ADDENDUM STATEMENT OF ENVIRONMENTAL EFFECTS – DA 2019/143

11-17 Columbia Lane,
Homebush

Prepared for
COLUMBIA LANES DEVELOPMENT PTY LTD
27 July 2020

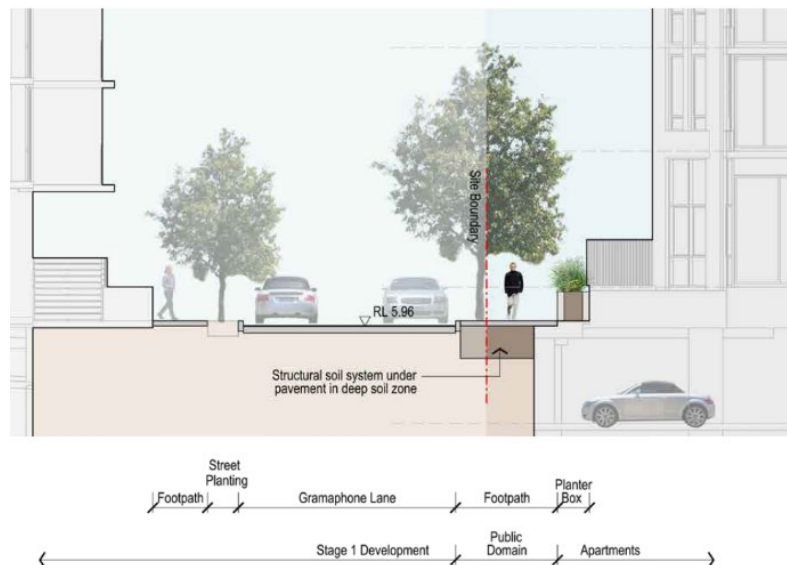
(iii) The submitted Urban Design report refers to generous planter boxes however these are approximately only 1.2m in depth and little detail is provided on how they are to be arranged.

The expectation of design excellence along this frontage requires a variety of landscaped spaces in different locations and at different levels.

Landscape strips with mature trees along the footpath should be provided, which will require revisions to setbacks. Council notes the basement car park limits opportunity for deep soil landscaping along Gramophone Lane, however upon considering the traffic and parking comments in this letter, Council believes this can be reviewed and deep soil landscaping provided.

The proposed development extends the deep soil zones under the widened footpath and incorporates redesigned planter beds along Gramophone Lane, as well as avenue street planting along the northern building frontage. This will create a more amenable pedestrian space and greener character for the public access link to the creek corridor.

The section diagram above obtained from the Landscape Report (**Appendix C**) illustrates the provision of deep soil and planter boxes along the Gramophone Lane frontage. The provision of a plaza in the north-western corner of the site will further contribute to the amenity and design excellence of this space.

Columbia Lane

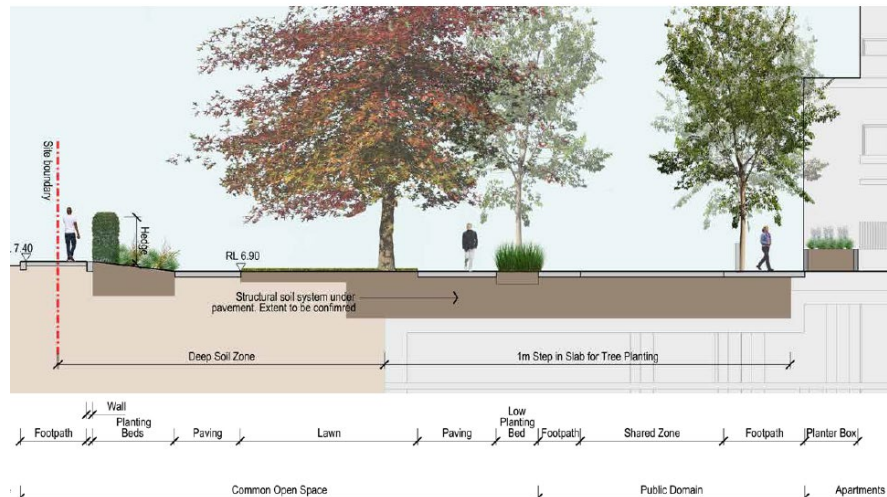
Considering traffic and parking comments, if the deep soil zone can be extended to capture the park side edge of Nipper Street, mature trees along the path would be ideal.

At the south eastern corner of the site, the podium stretches out to within a metre of the property boundary (Level 2-6 Architectural Drawings). At ground level, this area incorporates the edge of the bin collection area (refer to Section 6 for waste collection design comments).

The amenity of the south eastern corner of the site appears to have been neglected. It is expected that pedestrian movement along Nipper Street and under the train line will only increase in popularity encouraging greater movement of pedestrians along Columbia Lane.

The ground floor bin storage area and service vehicle entry has been shifted further to the west to increase the setback from the site boundary to open up sight lines down Columbia Lane, from the park to the substation and the bridge at the entry to the Sydney Trains Depot. Further, the amended proposal incorporates a 5.5m retaining wall surrounding the southern boundary of the waste storage area to provide visual screening to this area. The proposed materiality is dark Austral brick to correspond with the building elevation.
